REGIONAL REVIEW NOTIFICATION

Name of Proposal: RC-17-03SS 105 River Park Drive

Description: An application for a Metropolitan River Protection Act (MRPA) Certificate for additions to an existing single-family house.

**105 River Park Drive Reanalysis
City of Sandy Springs**

SURVEY TO MEET THE CITY OF SANDY SPRINGS ARC REQUIREMENTS:

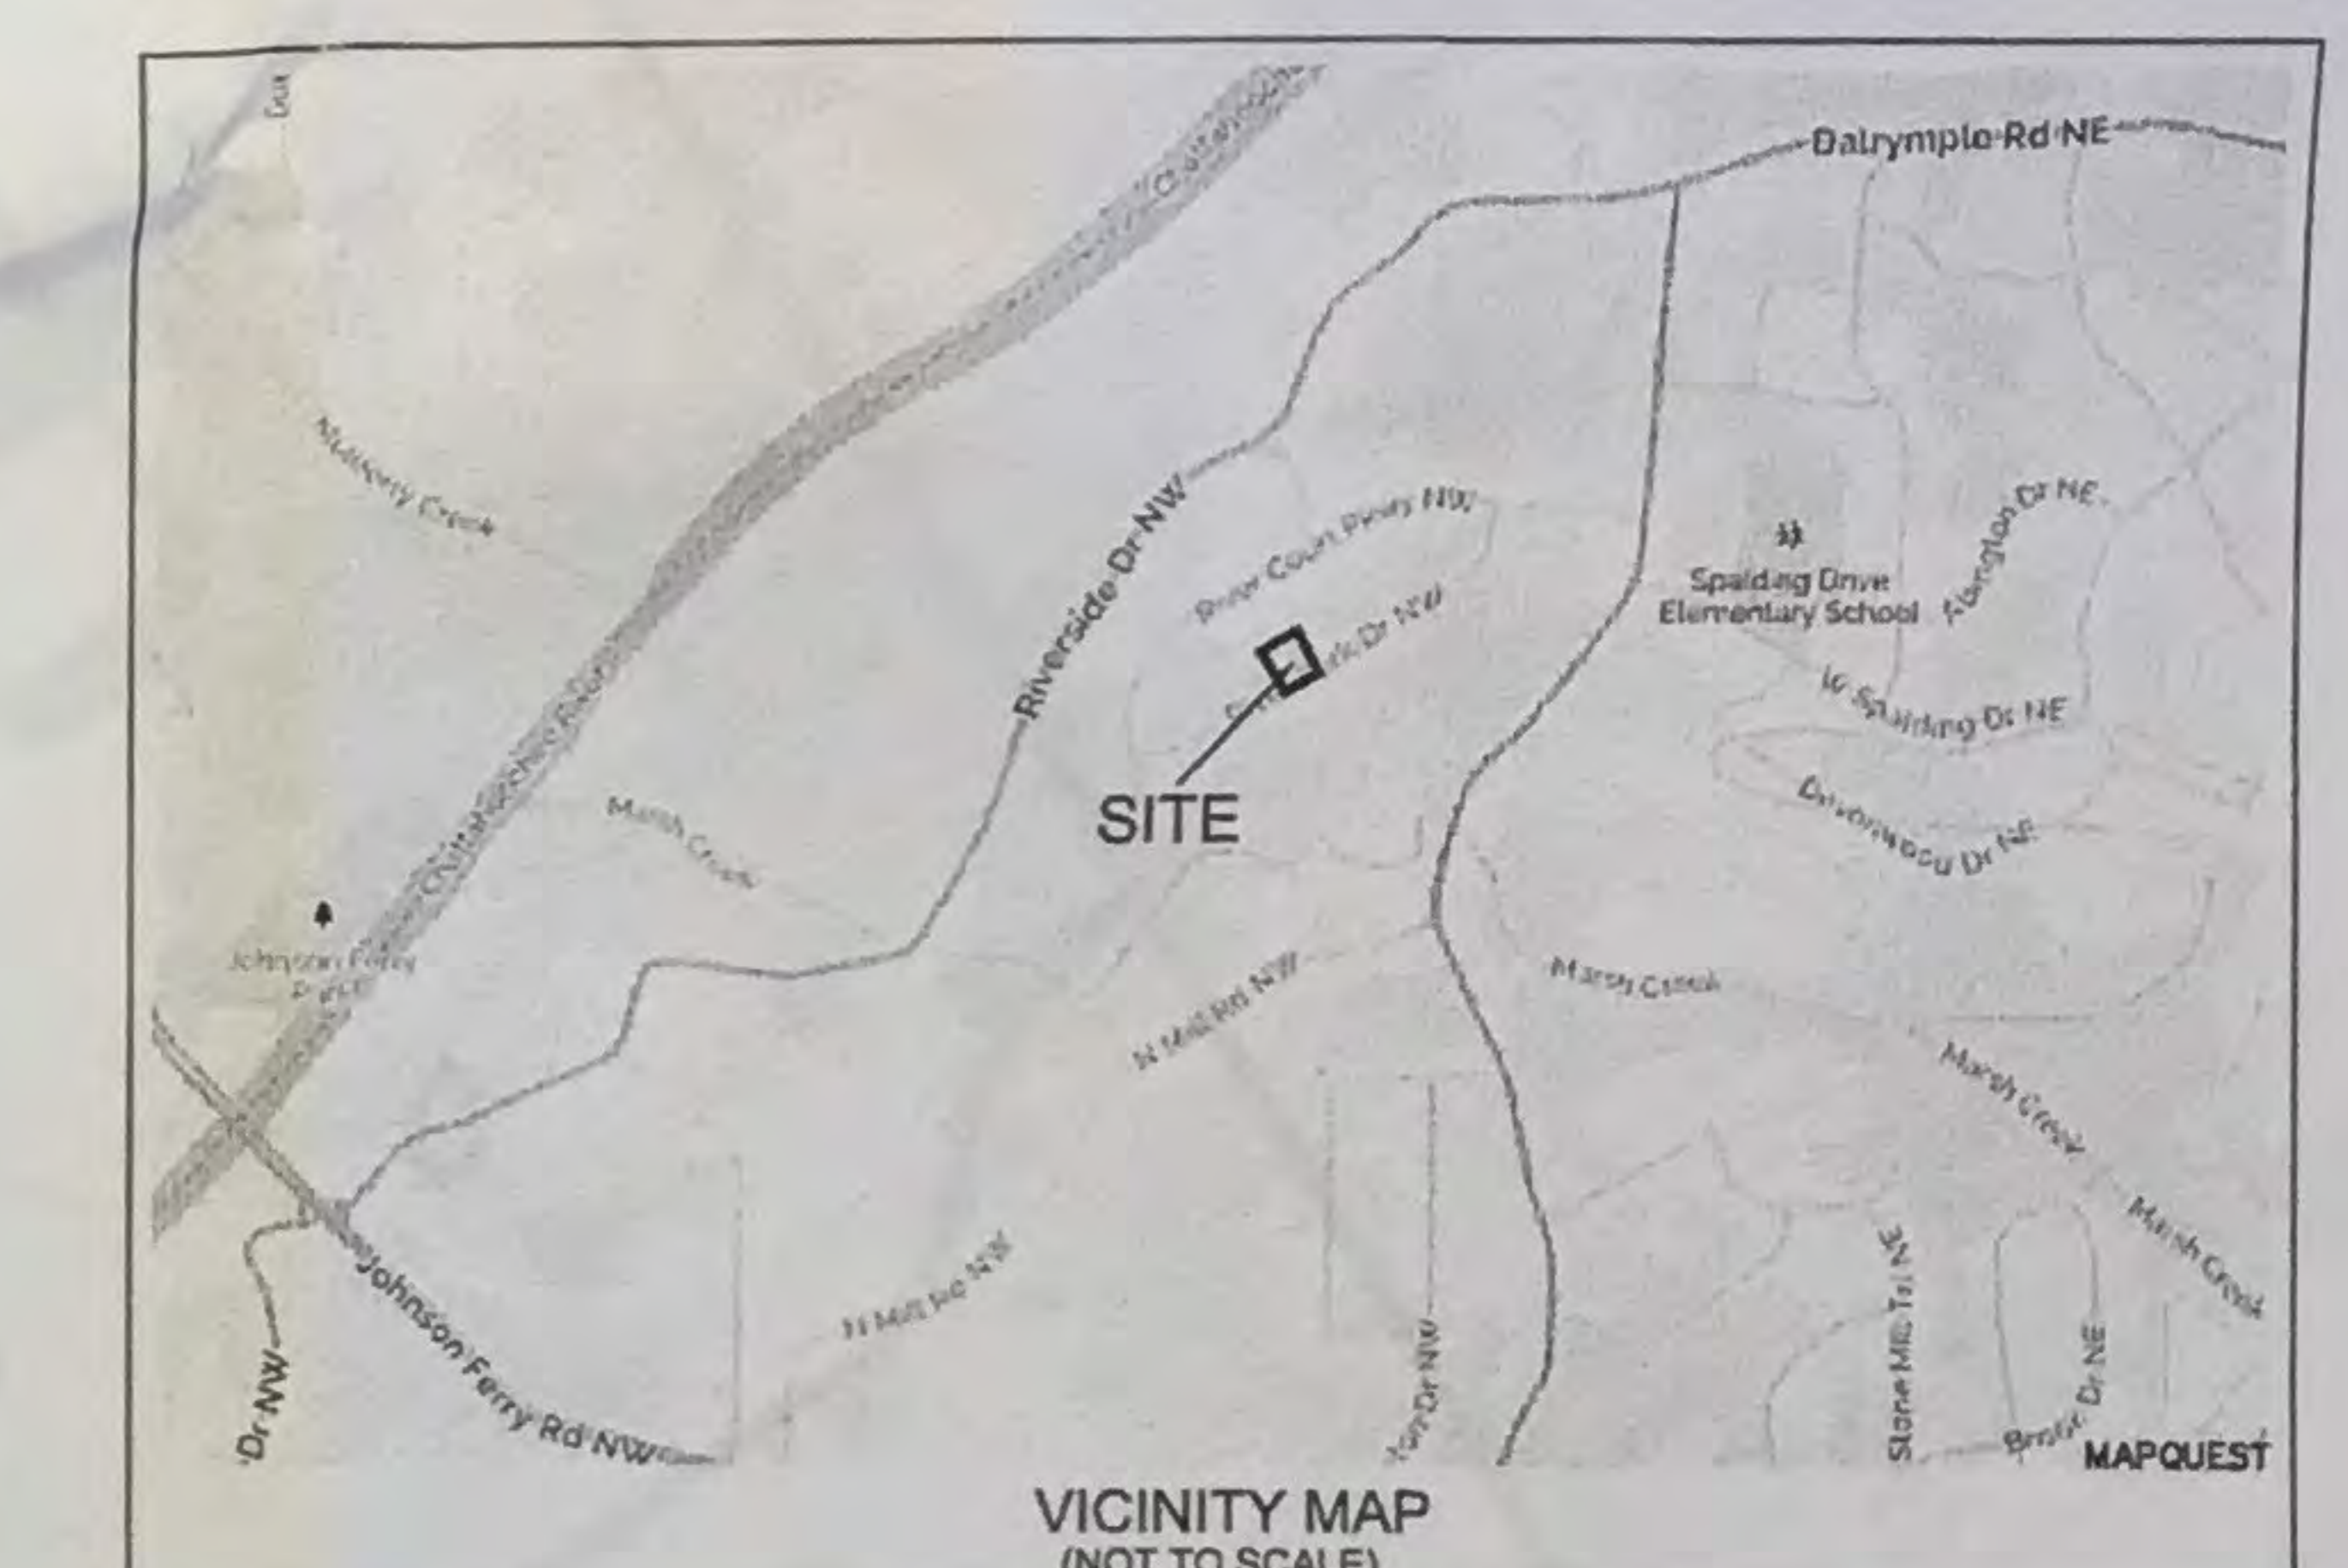
consistent #'s throughout

- all work ok
SMS
10/4/17
- ① - entire lot in corridors
 - ② - TOTAL SF of lot varies by 1000 SF between as-built and proposed (as-built correct based on #'s and my measurements)

- ③ - as built shows imp. as 8071 - primarily correct based on my measurements - but proposed shows house & driveway at 8412 - not counting walkways and patio - which is right

- ④ - Cul. includes imp. In this case, it would be existing imp., area around new construction (minimum 5' perimeter + mulch play area).

- ⑤ - Curved to D - 38% imp 50% L.O. OK to L.O. (correct) before in TAMP by my measurements 9442 total - 8115 SF over max. - no credit for gravel that will be used for vehicle, fat buffer - parking drive.

- ⑥ - Analysis: corrected as 'C' ~~+12,948 SF TAMP.~~
TD - NO IMP. IN D -
can dump - total
about 12,200
